From: Clarke M Saunders <cmsaunders@aep.com>
Sent: Tuesday, December 16, 2025 3:29 PM
To: Doug.Clark@dot.ohio.gov
Cc: TL_PublicProjects; Ram Nunna
Subject: RE: AUG-33-Willipie Interchange EB Loop Ramp Truck parking, PID 122890 Utility Verification

For the ODOT project AUG-US33-Willipie St Infield Truck parking PID 122890 in Auglaize County, ODOT is constructing a Truck parking area at the interchange of US 33 and Willipie St. Please confirm that your utility has or has not any conflicts with this project. See attached plan set for your review.

| Title | |
|--|--------------------|
| AUG-US33/Willipie St Infield Truck Parking | |

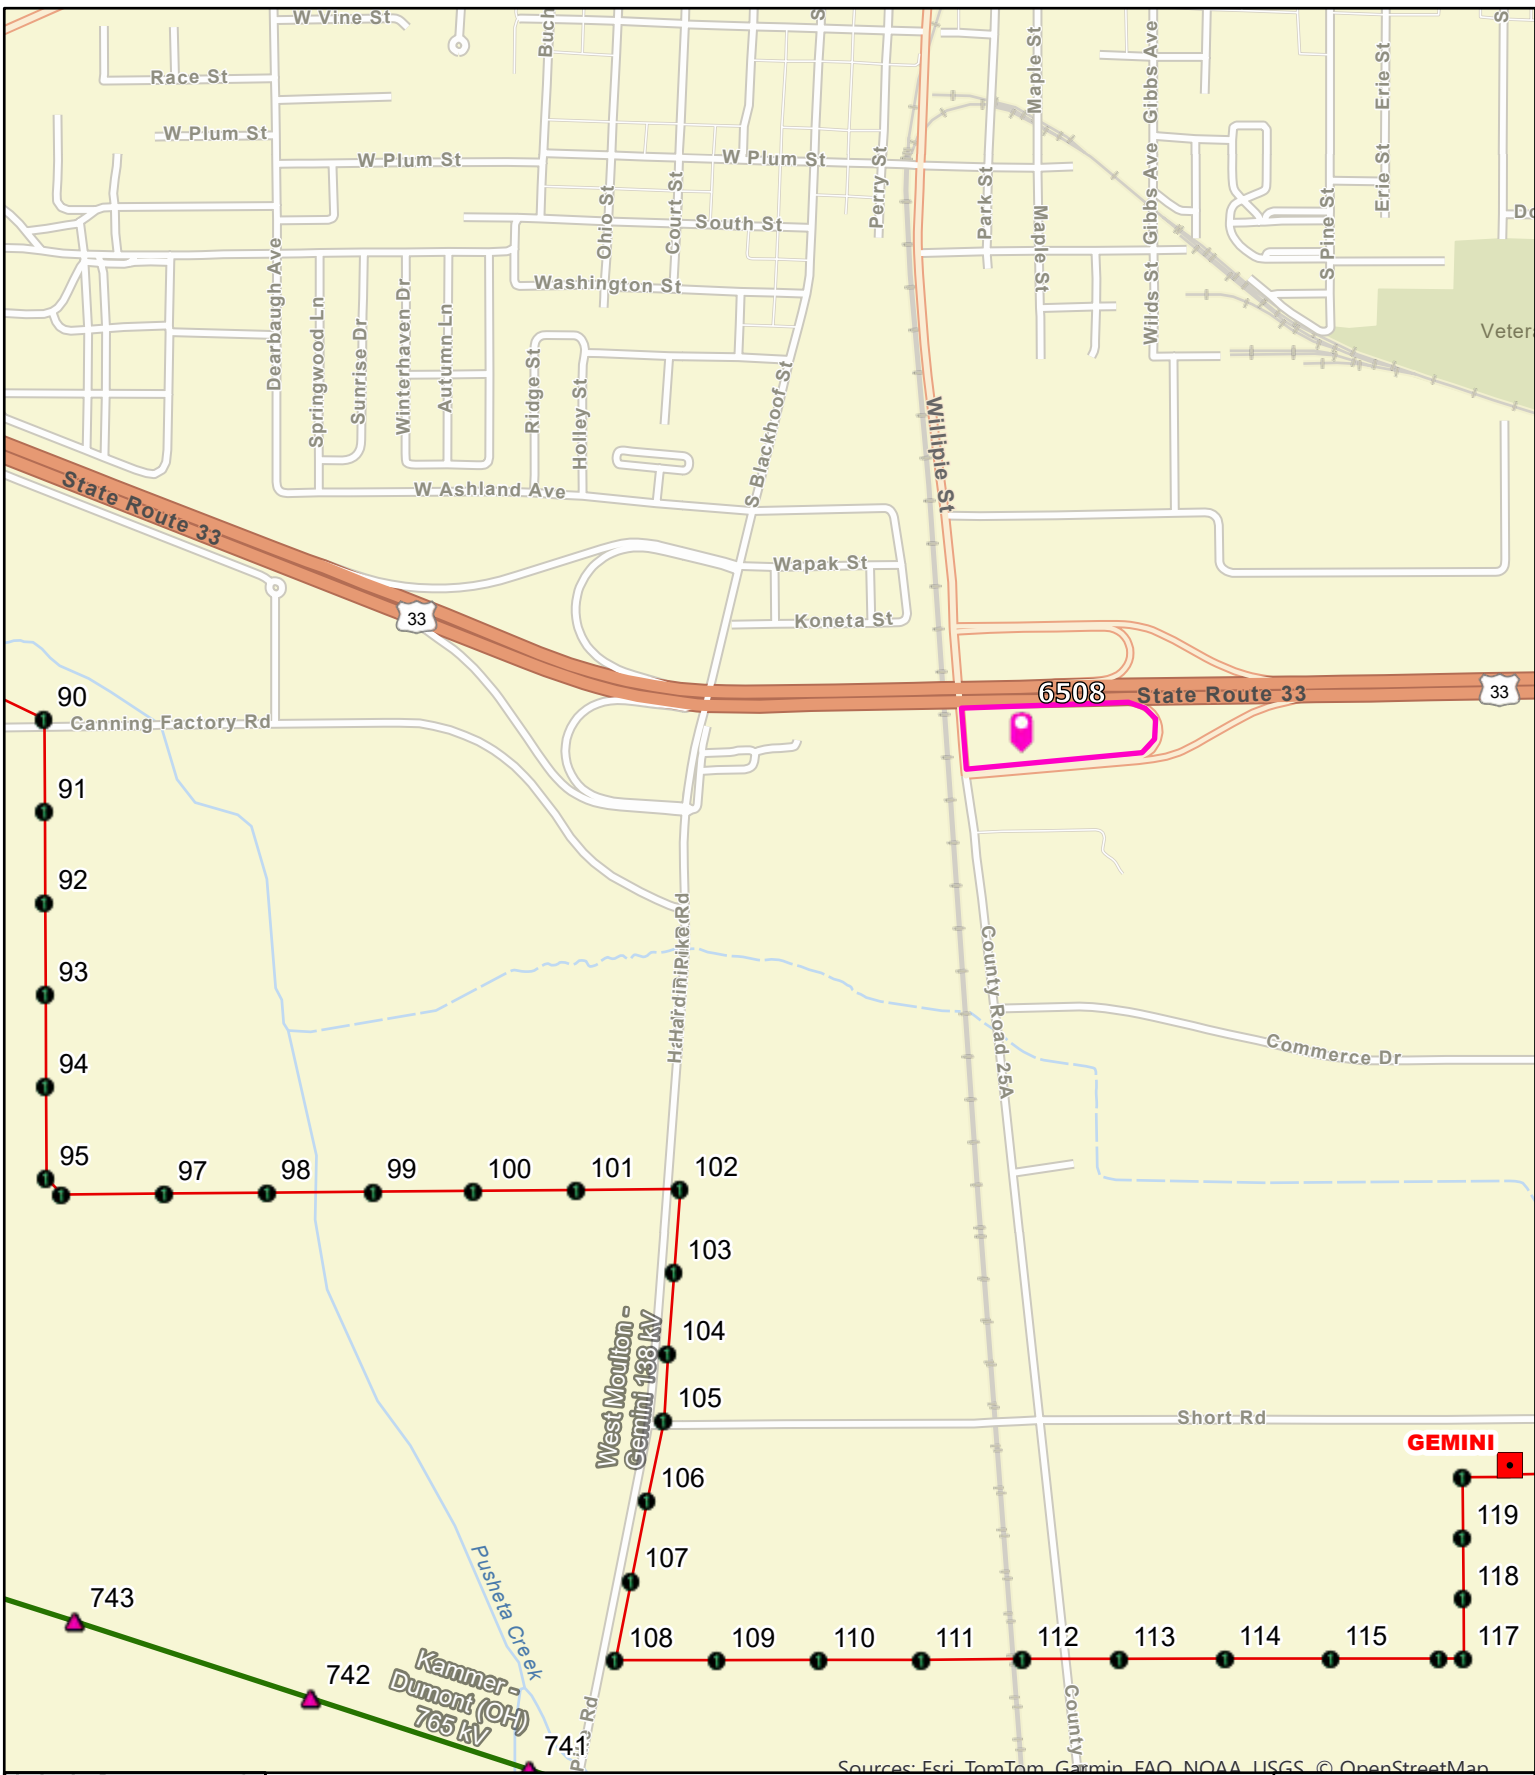
Please see the attached map that shows the proposed project location in pink.

Our records indicate that AEP Transmission does not have any facilities within the project area. The facilities that you mentioned that run along Willipie Street appear to be AEP Distribution facilities. Clark will have to let you know if they are shown properly on the plans.
